ADDENDUM NO. 04

Project: **A NEW TRANSPORTATION FACILITY**
Dickinson Independent School District

Project No.: **0806**

<p>A NEW TRANSPORTATION FACILITY DICKINSON I.S.D.</p>	<p>ADD-4-1 0806 1"=30" 03/31/2010 C2.05</p>
--	--

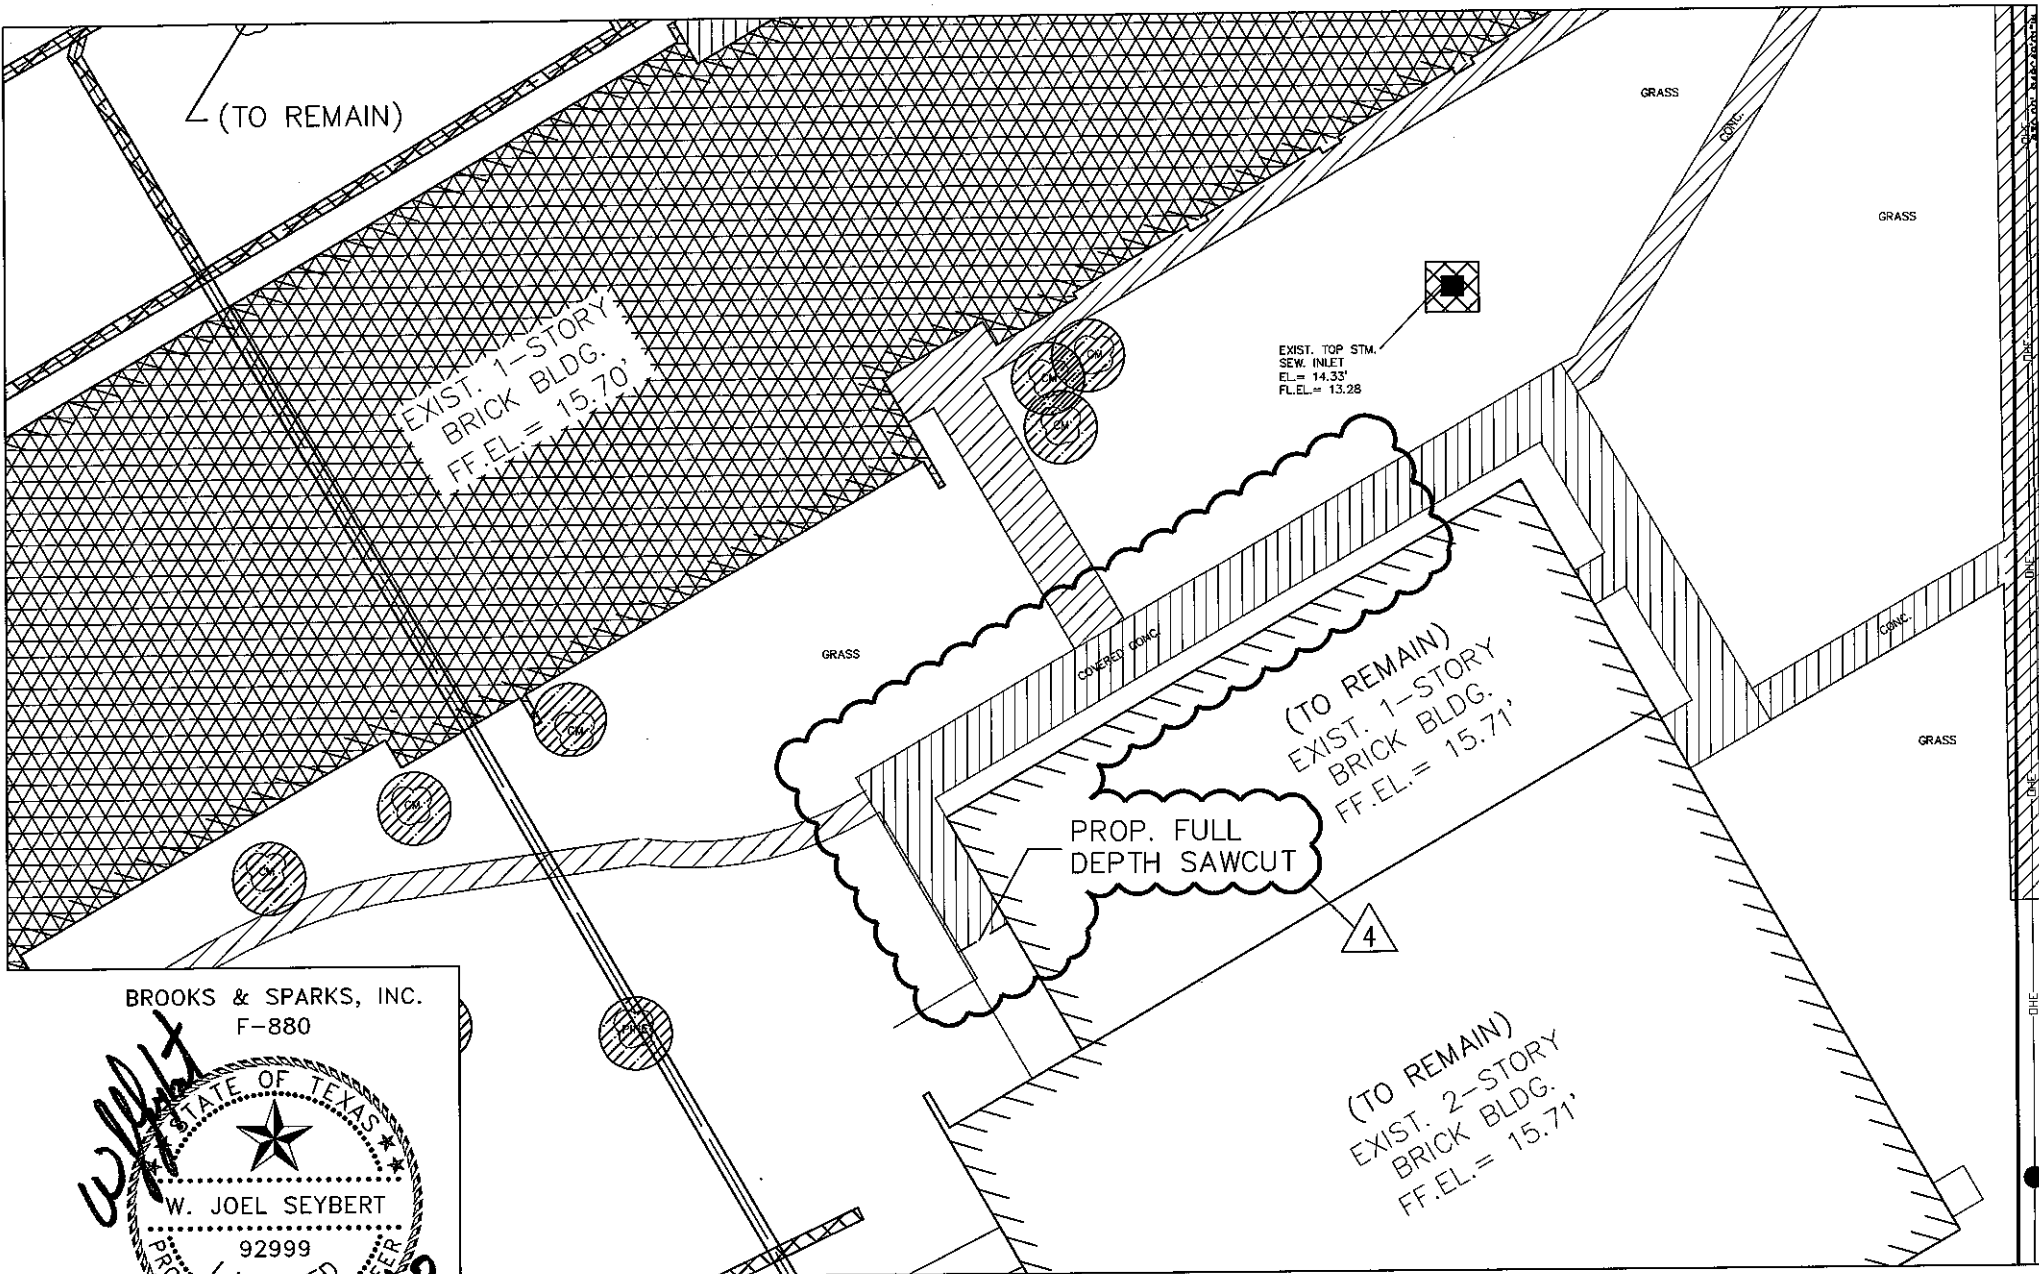
7. Sheet C2.05 Demolition Plan (Sheet 2 of 3): Remove additional sidewalk to install proposed water and sanitary utilities as shown on attached sketch **ADD-4-1**.

<p>A NEW TRANSPORTATION FACILITY DICKINSON I.S.D.</p>	<p>ADD-4-2 0806 1"=30" 03/31/2010 C2.07</p>
--	--

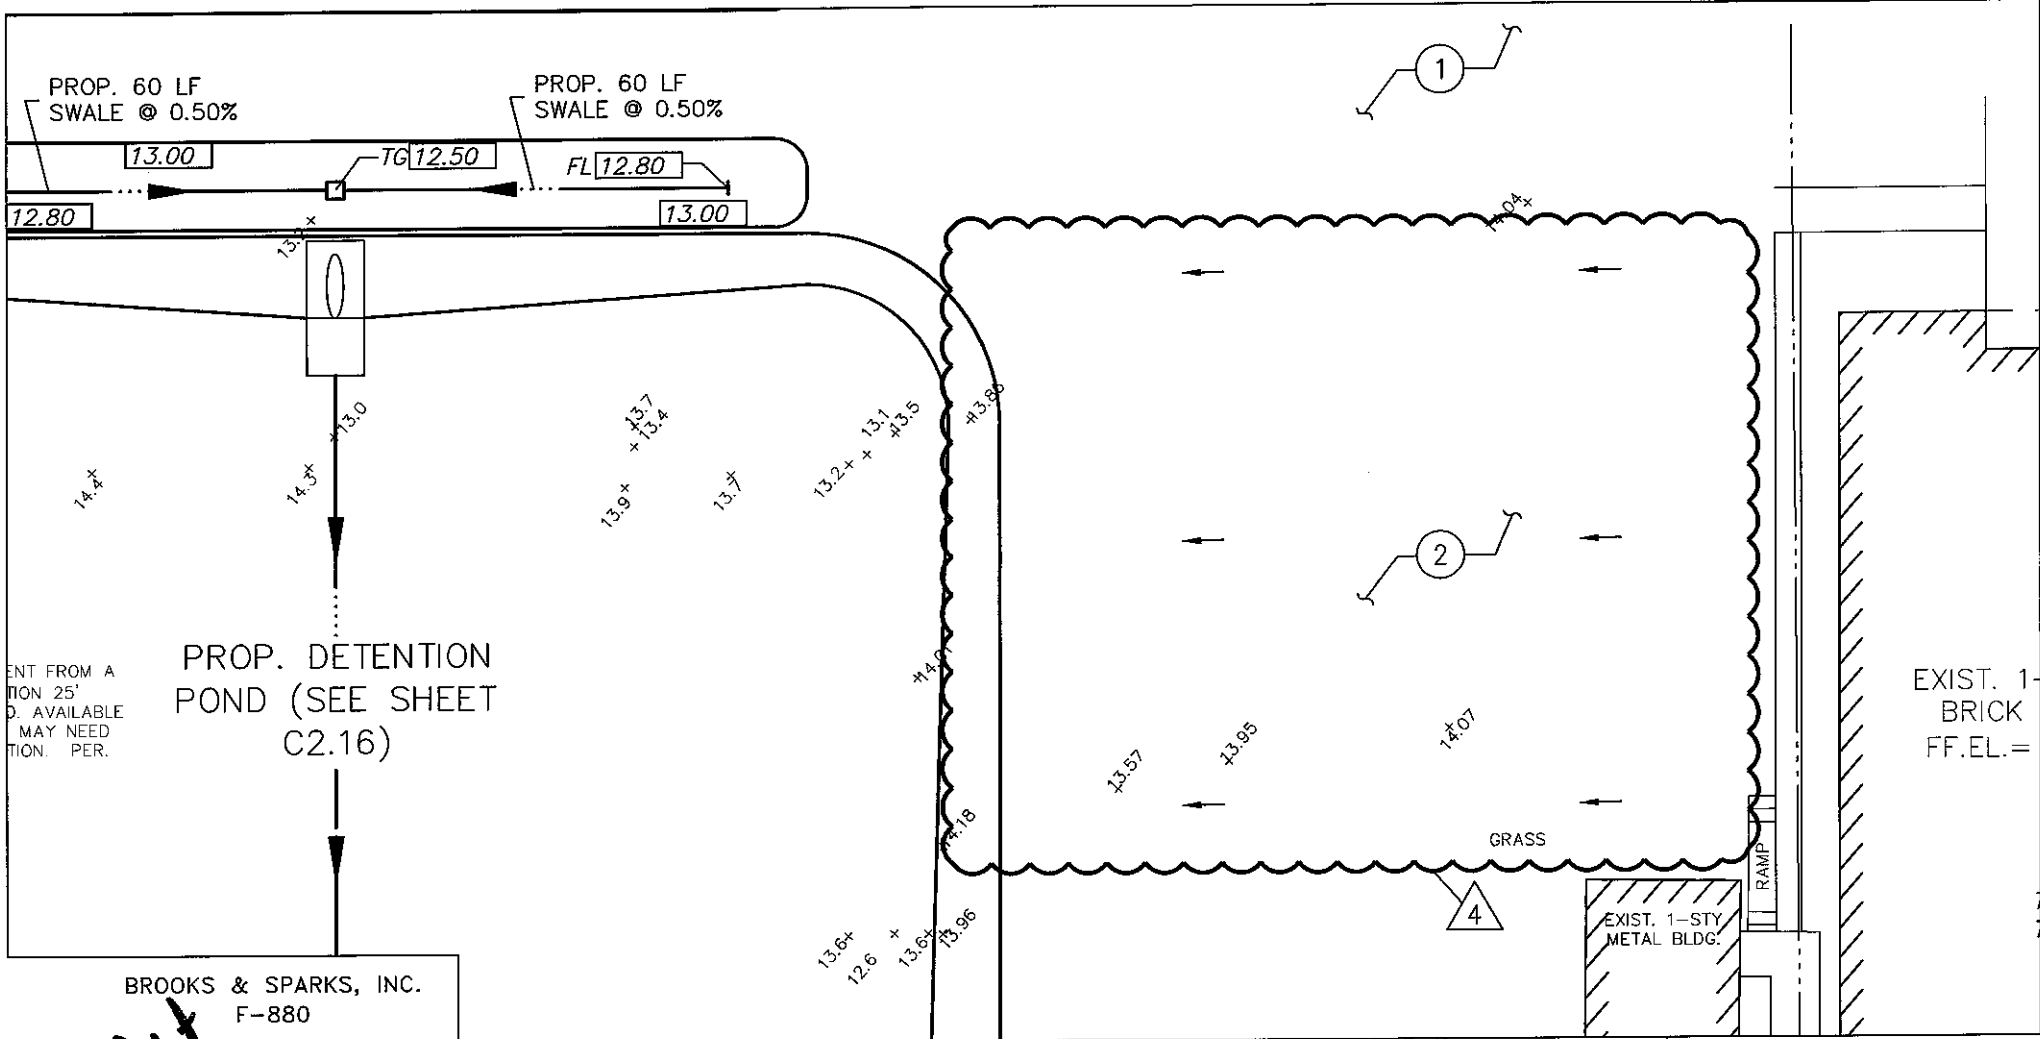
8. Sheet C2.07 Grading Plan (Sheet 1 of 3): Add slope arrows and note to area behind existing building "H" and proposed detention pond as shown on attached sketch **ADD-4-2**.

2. CONTRACTOR TO GRADE AREA TO SHEET FLOW TO PROPOSED
DETENTION POND. CONTRACTOR TO HYDROMULCH SEED AREA
UNTIL STAND OF GRASS IS ESTABLISHED.

<p>A NEW TRANSPORTATION FACILITY DICKINSON I.S.D.</p>	<p>ADD-4-3 0806 1"=30" 03/31/2010 C2.08</p>
--	--

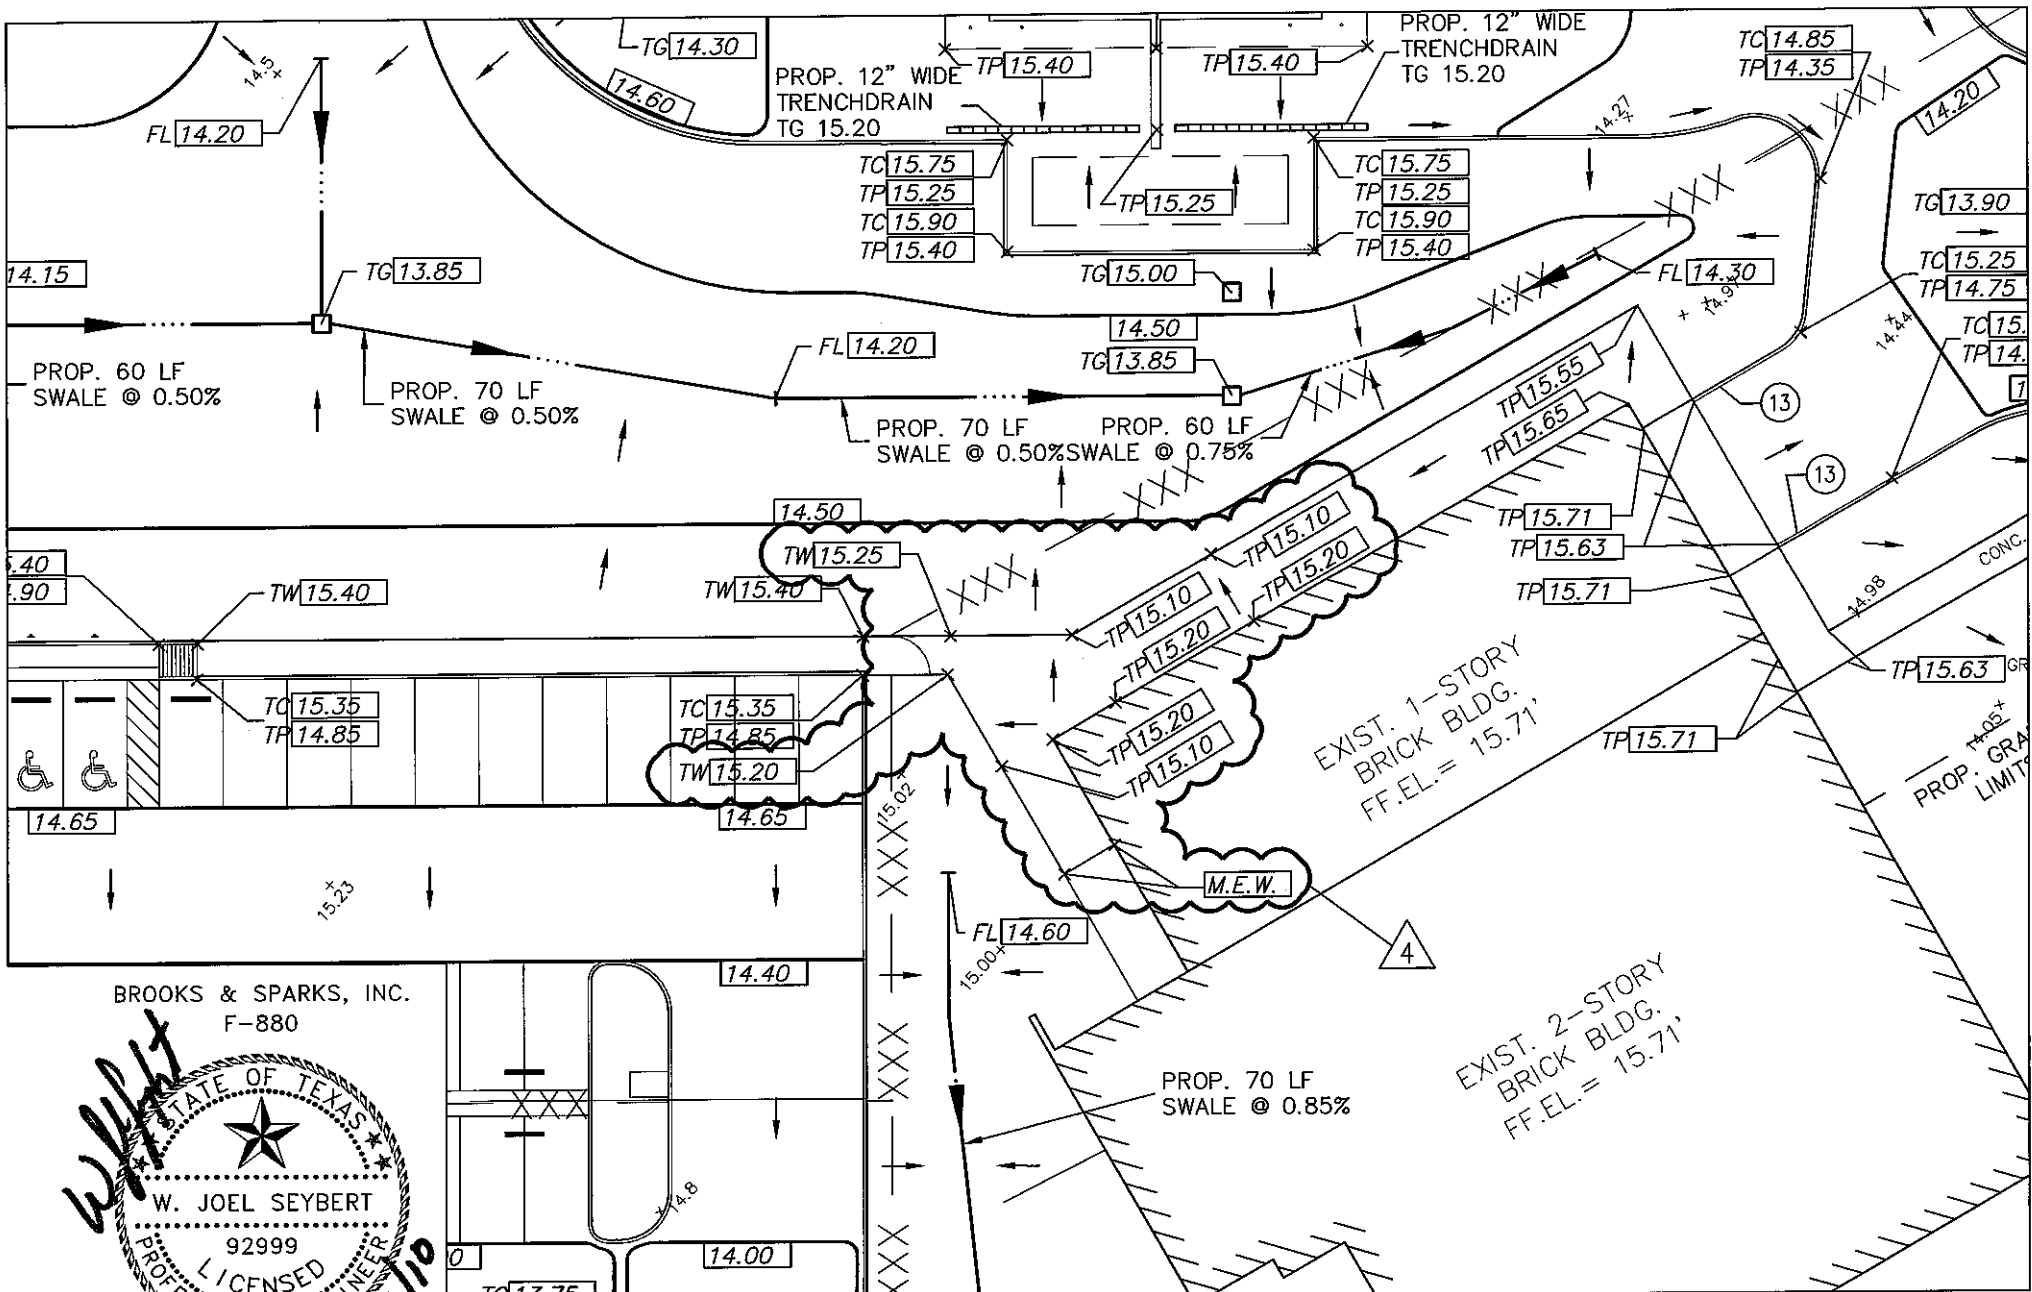
9. Sheet C2.08 Grading Plan (Sheet 2 of 3): Add additional sidewalk with grading to existing gymnasium as shown on attached sketch **ADD-4-3**.
10. Sheet C2.11 Storm Sewer (Sheet 2 of 3): Remove proposed storm leads from floor trenchdrain as shown on attached sketch **ADD-4-4**.

ADD-4-5
0806
1"=30"
03/31/2010
C2.11

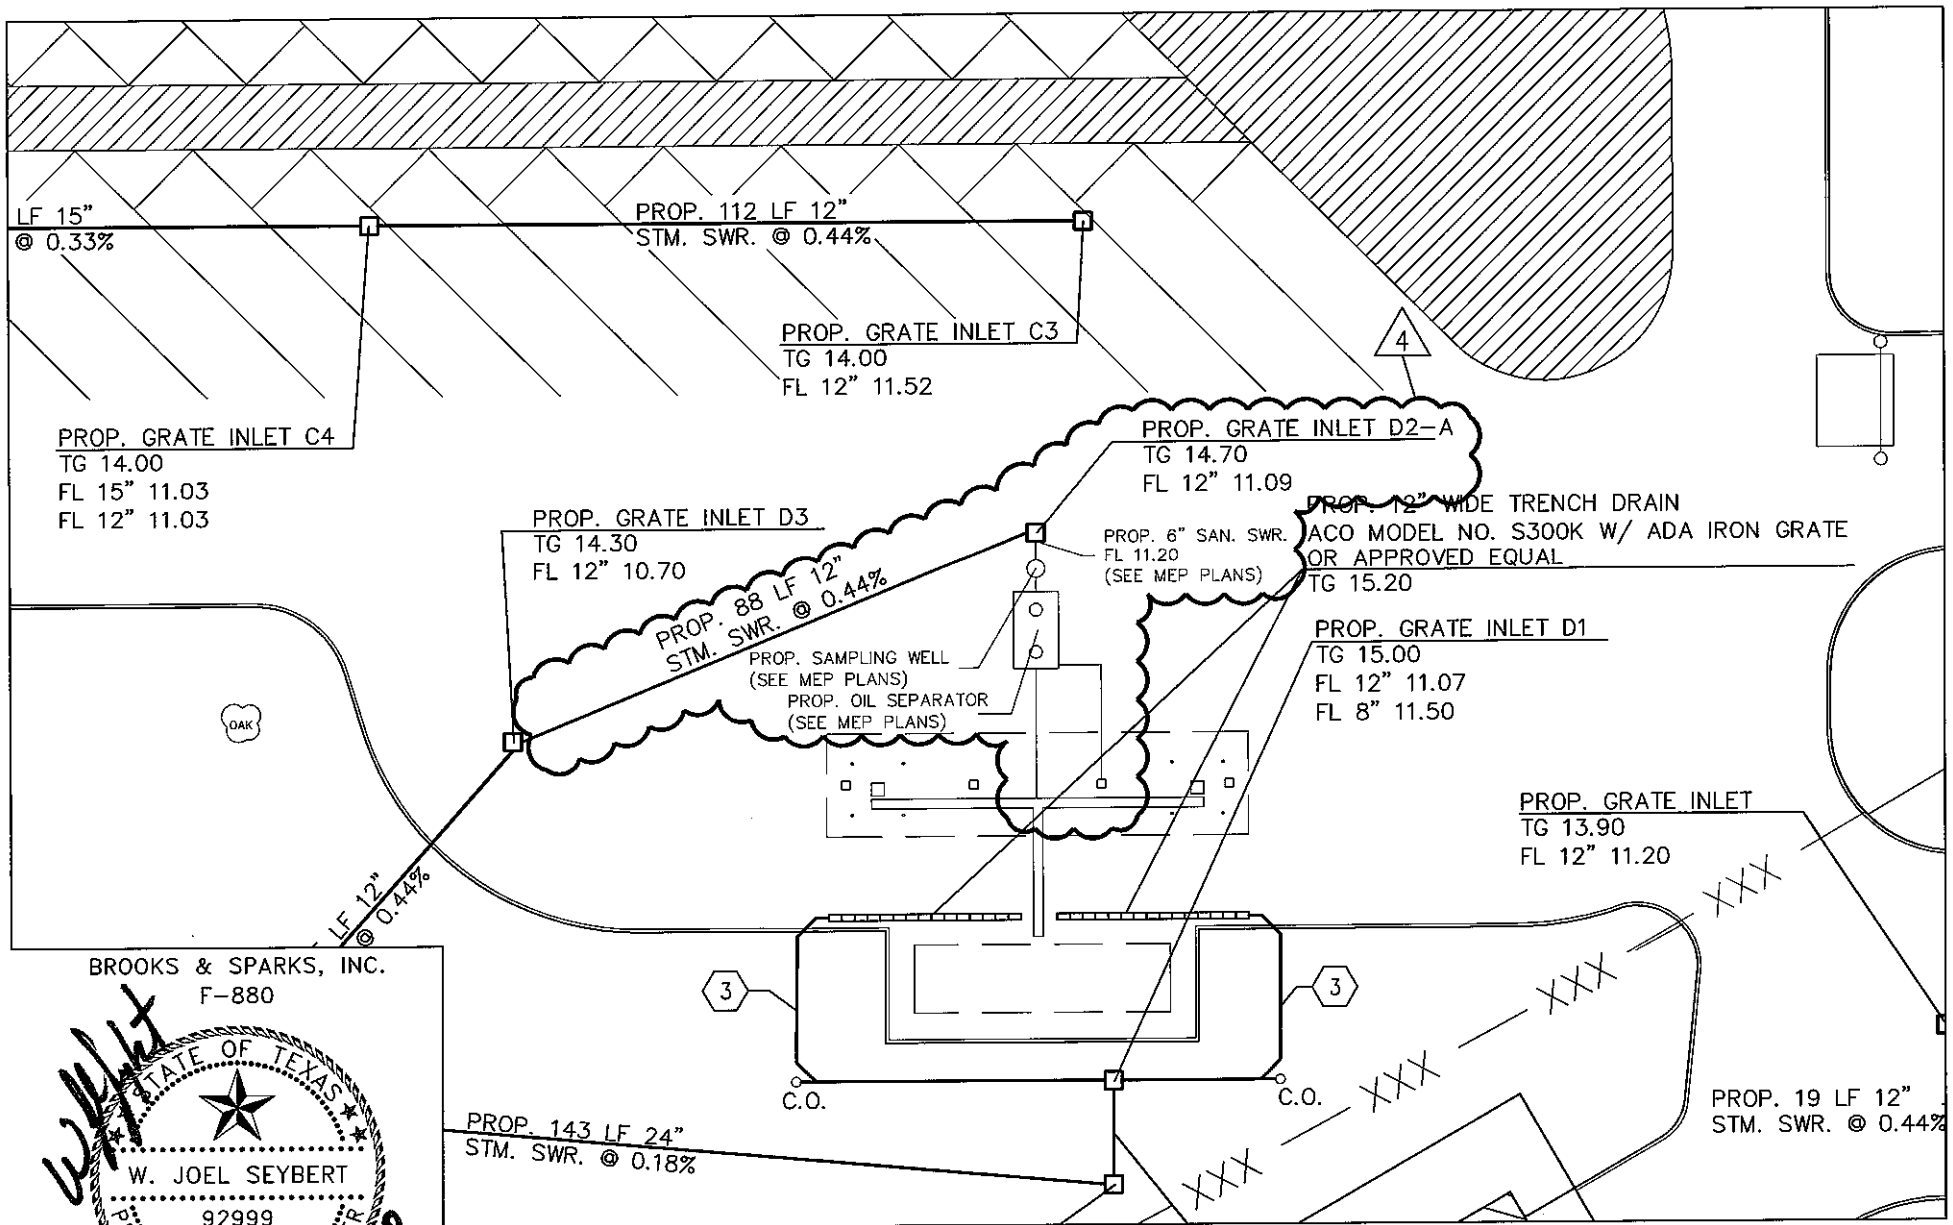
11. Sheet C2.11 Storm Sewer (Sheet 2 of 3): Add proposed oil separator and connect to proposed storm sewer as shown on attached sketch **ADD-4-5**.
12. Sheet C2.18 Water and Sanitary Sewer Plan (Sheet 2 of 3): Add proposed 2" water line to serve bus rinse as shown on attached sketch **ADD-4-6**.
